Our Ref / Ur n-àireamh-iùil: 16/02464/FUL & 16/05382/FUL  
Your Ref / Ar n-àireamh-iùil:

Date / Ceann-là: 06 December 2016

**Planning Permission 16/02464/FUL - Installation of an Ultra Violet Treatment Plant at the Ardersier Wastewater Treatment Plant at Land 40m West of Wastewater Treatment Works, Ardersier**

1:250 @ A1	PLANNING ISSUE				
Project Title <b>ARDERSIER WwTW GROWTH</b>					
Drawing Title <b>SITE LAYOUT PLAN LANDSCAPING - SECTION B-B</b>					
ELLIPSE EQUIPMENT No. 5000061980					
ELLIPSE PLANT No. STW000379		AUTOCODE No. 5001290000

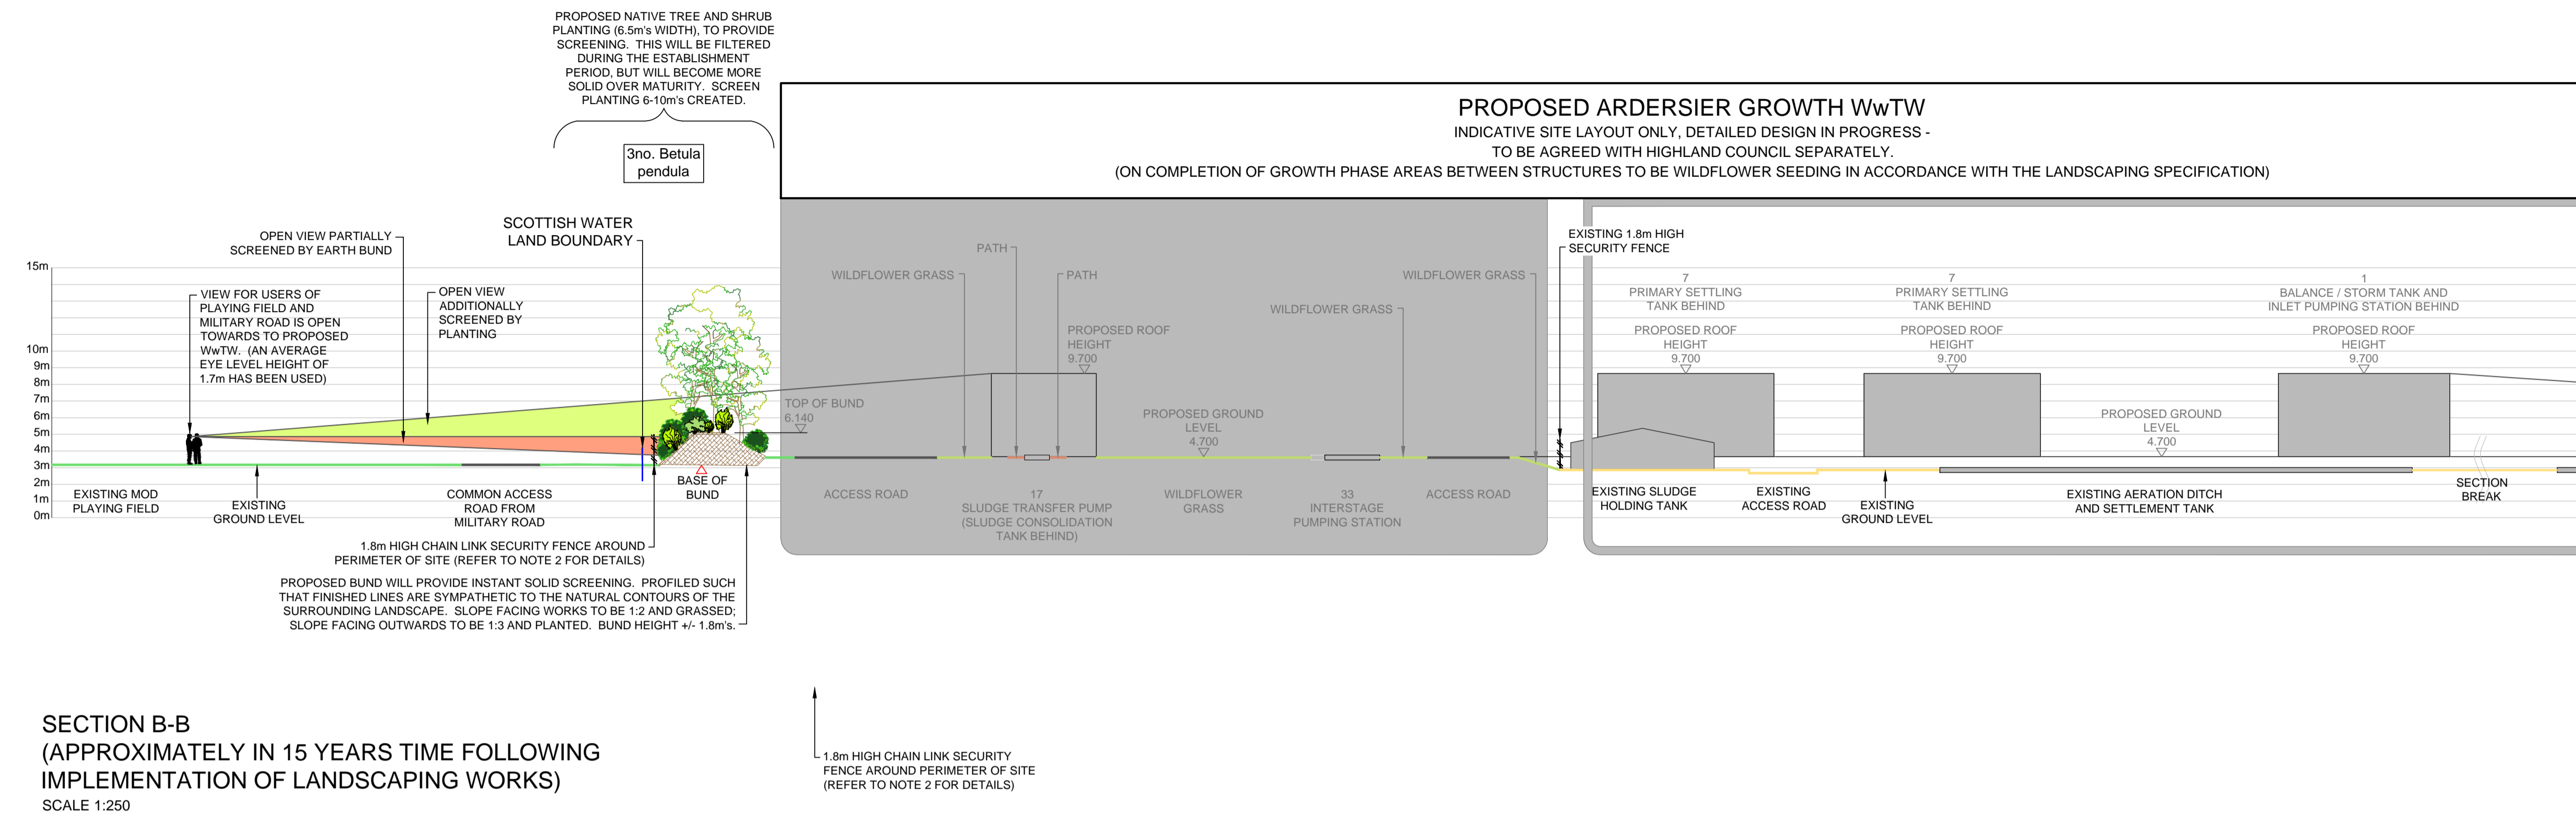
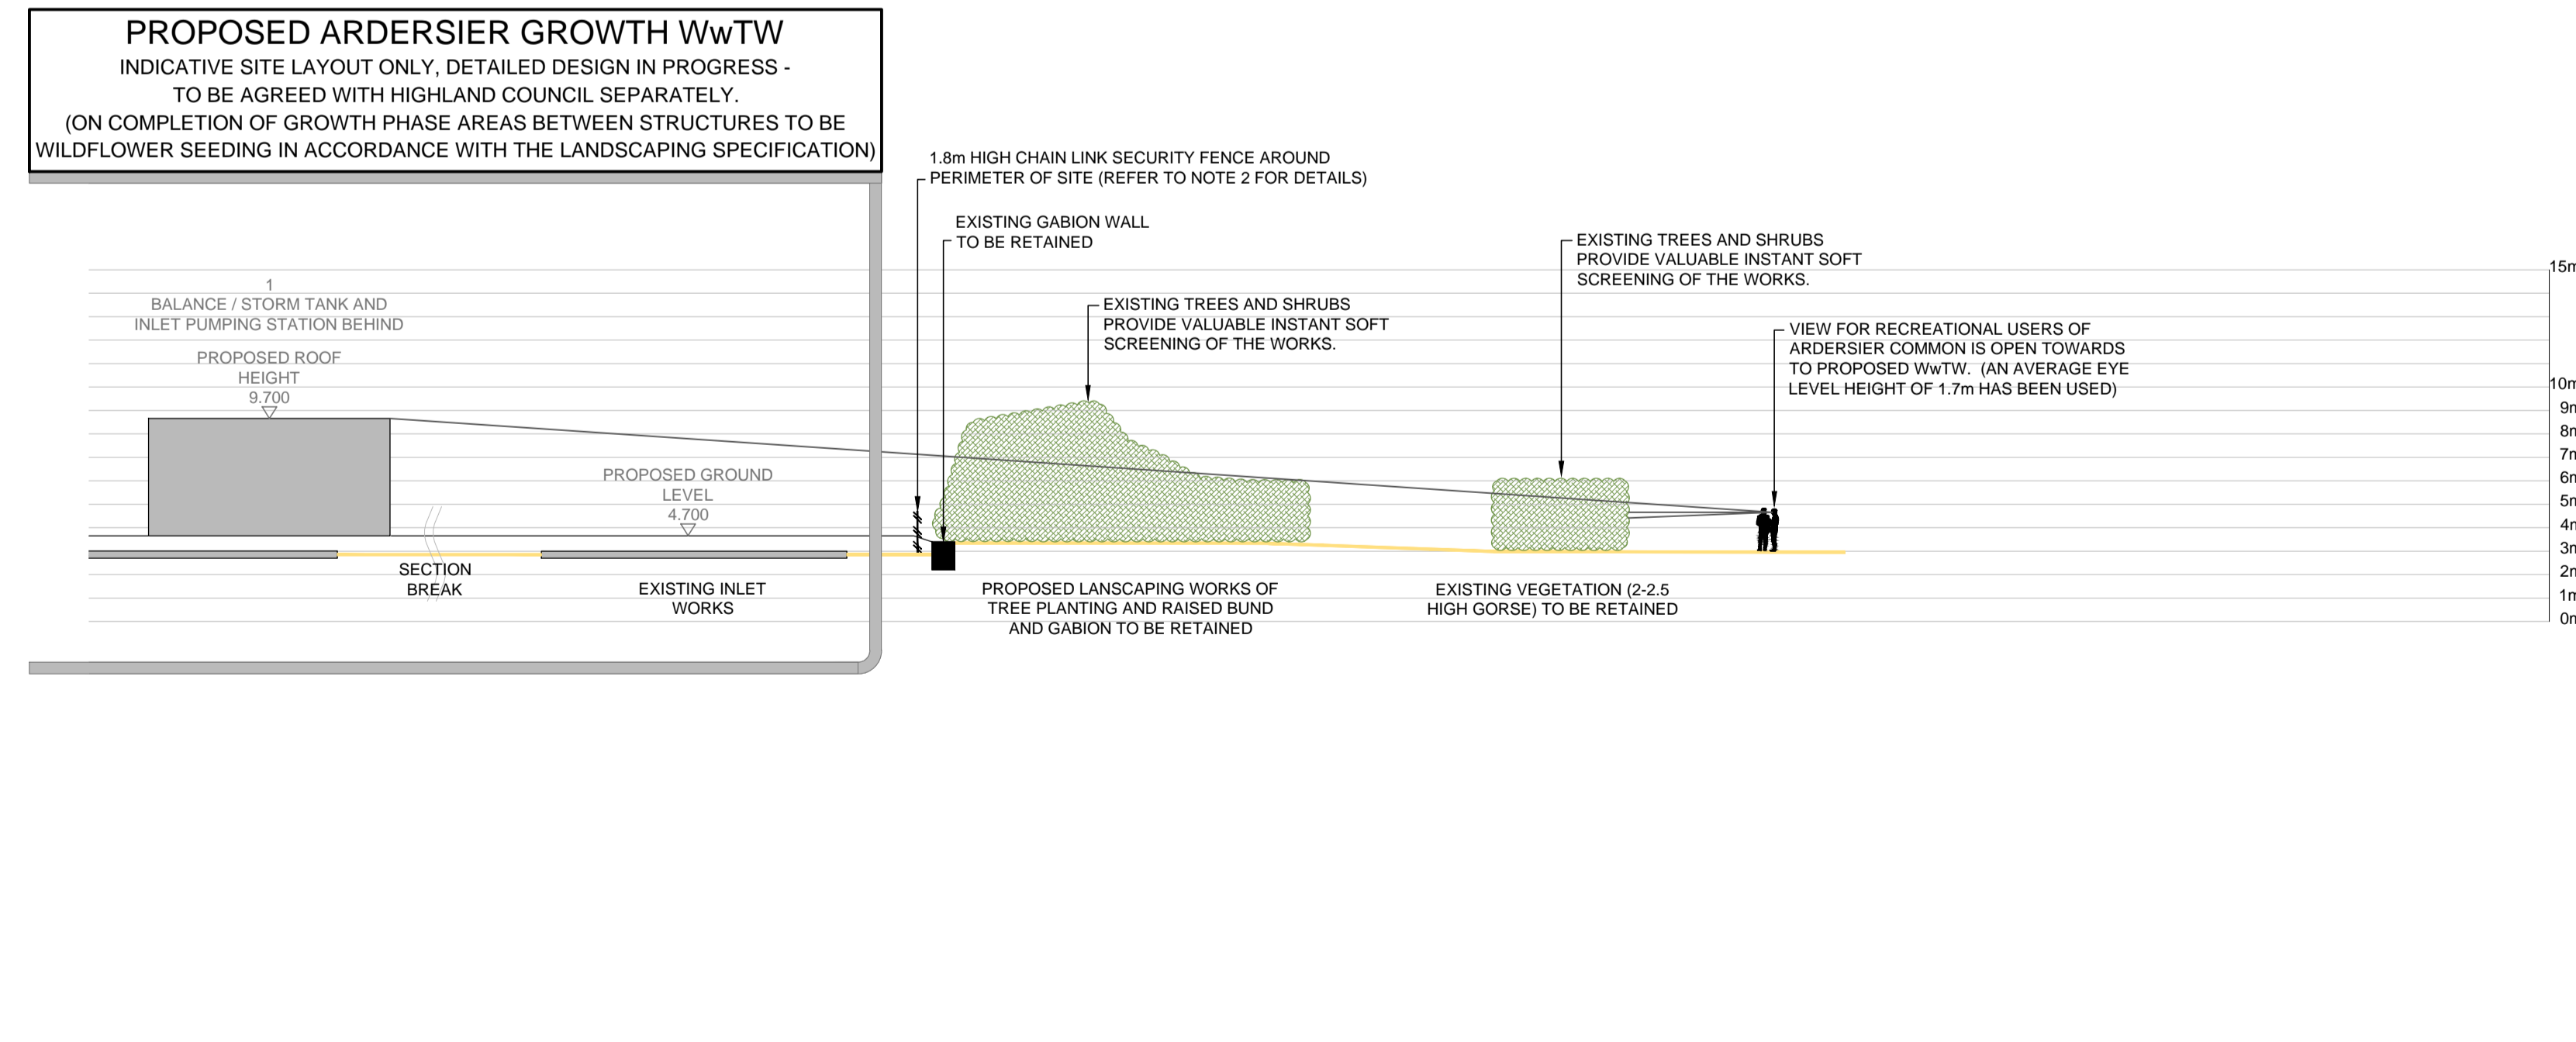
Having reviewed the submitted plans and information I am content that the level of landscaping proposed and the planting mix is appropriate to the site. I am also content that the fencing proposed is sufficient. In considering whether these accord, I have considered the location of the site and the surrounding sensitivities including, but not limited to, climate, existing planting / landscaping and nature conservation. As such the following plans are hereby approved:

- Drawing Title: Site Layout Plan Landscaping - Section B-B, Drawing Number 5000061980-WW-DRA-04158004-0C, Dated 02/12/16, Prepared by ESD for Scottish Water and submitted to the Planning Authority on 02 December 2016.
